RE: Process Wastewater Evaporation Pond

Geokinetics Kamp Kerogen

ACT/047/002

RESPONSE TO QUESTIONS IN REGARD TO THE EVAPORATION POND

FIGURE 2. TOPSOIL STOCKPILE DESIGN

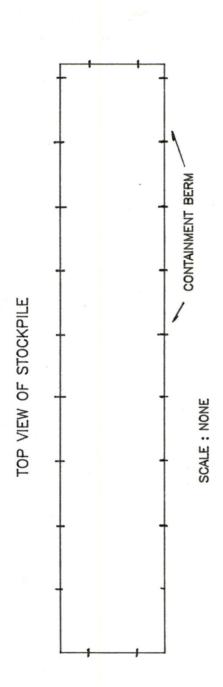
4. Submission of Final Soil Stockpile Protection Plan

In order to adequately protect the stored topsoil, measures will be employed to limit the effects of overland flow as well as erosion of the stockpile surface. These measures will include: (1) the use of diversion channels for conveying surface runoff away from the pile; (2) constructing sediment containment berms along the peripheral of the pile; (3) mulching with straw, and seeding with a temporary plant cover; and (4) limiting the side slopes of the pile, as well as overall depth of the pile. A typical stockpile cross section is given in Figure 2.
